Precautions for the assembly of the front mudguard extension part no.56410801B

Multistrada 1200 MY 2010-2018 (all model versions)

Multistrada 1260 MY 2018-2019 (all model versions)

Service Repair Bulletin SRV-SRB-19-027

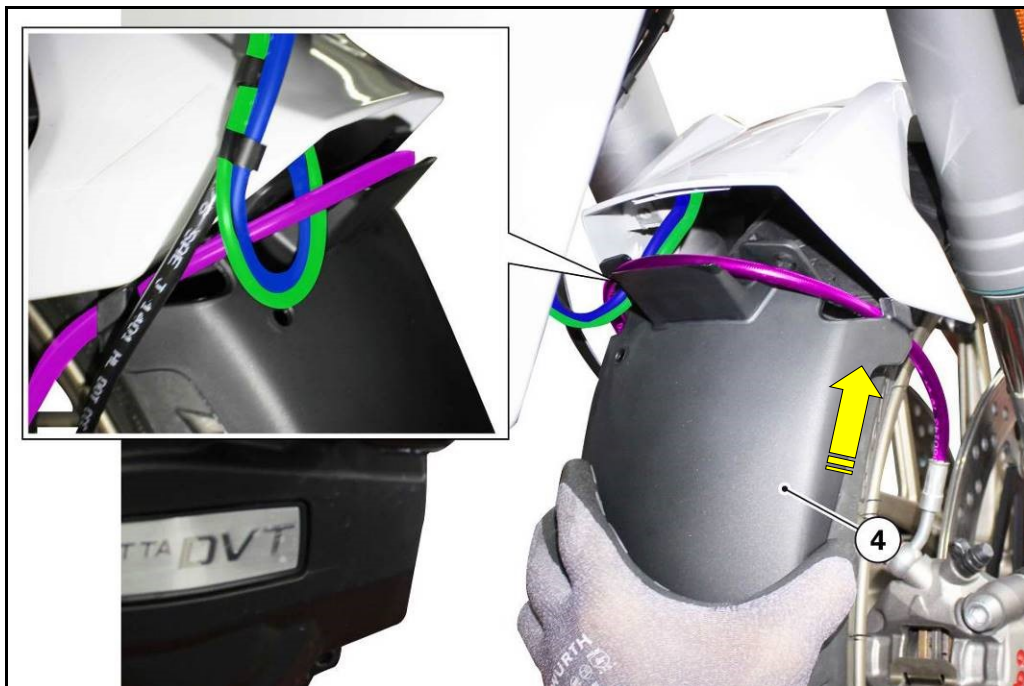
1. Remove the **button tie (1)** L.62 mm
2. Remove the **2 screws M5x14 (2)** securing **bracket (3)** to the front mudguard

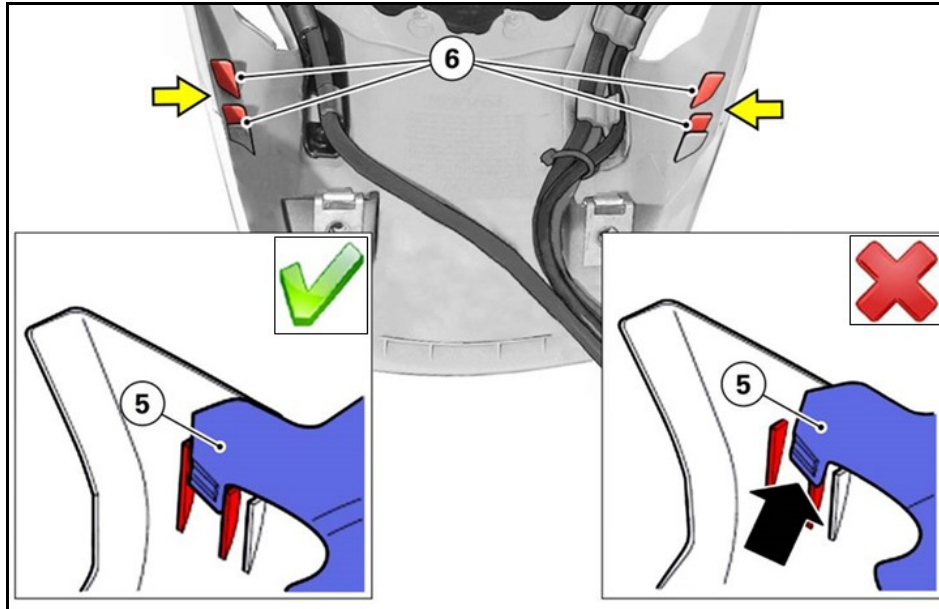
3. Fit the front mudguard **extension (4)** aiming front brake caliper hoses as shown in the figure

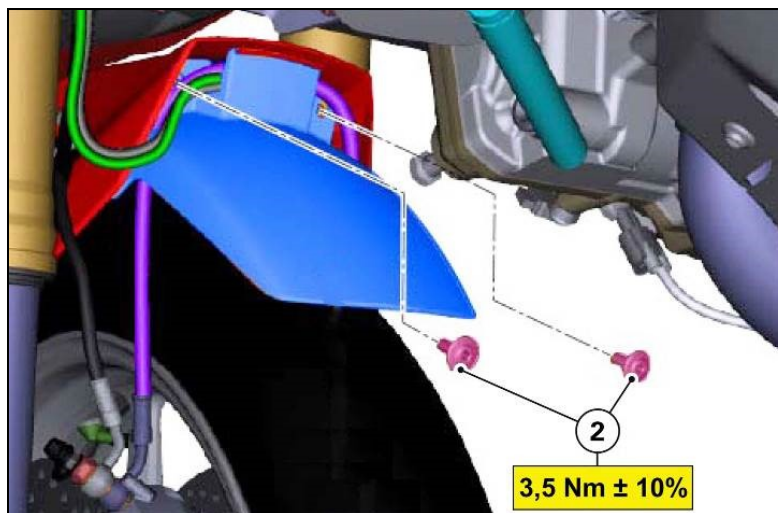
Make sure that the **2 tabs (5)** of front mudguard extension are positioned between the **tabs (6)** of the front mudguard.

4. Tighten the 2 screws M5x14 (2) to 3.5 Nm ± 10%.

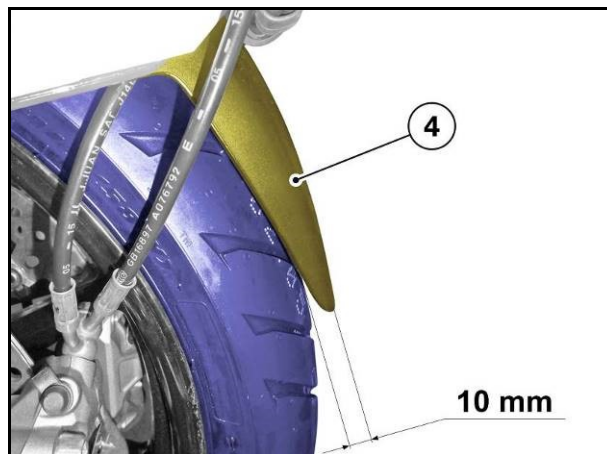
Make sure that front mudguard profiles are aligned as shown in the figure.

Check that the distance between front tire and front mudguard extension (4) is equal to 10 mm.

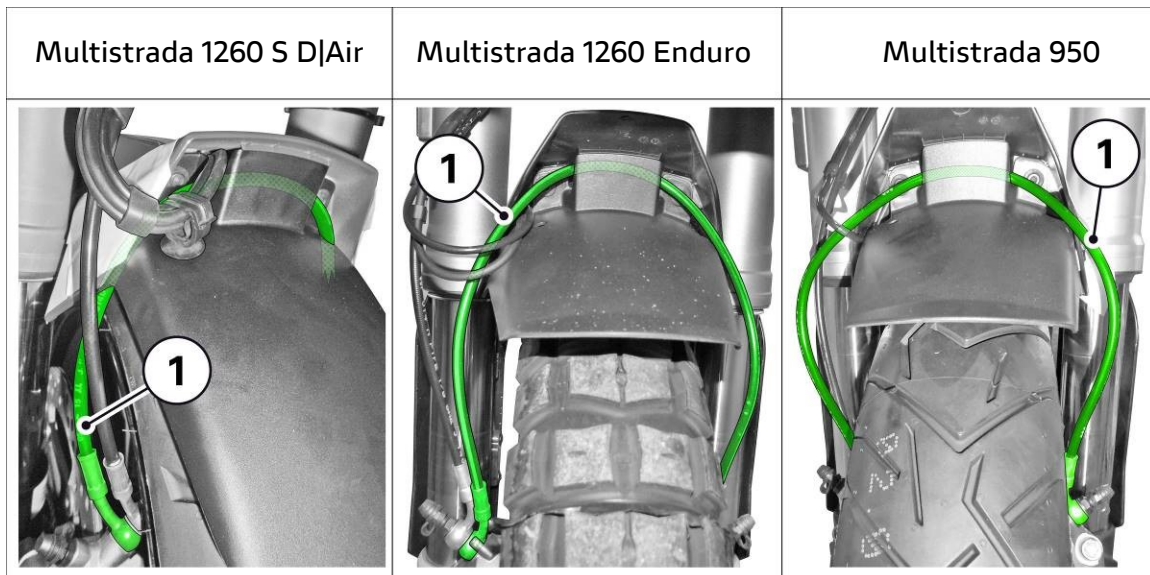
The images below define the positioning of the **hose (1)** that connects the front brake calipers.
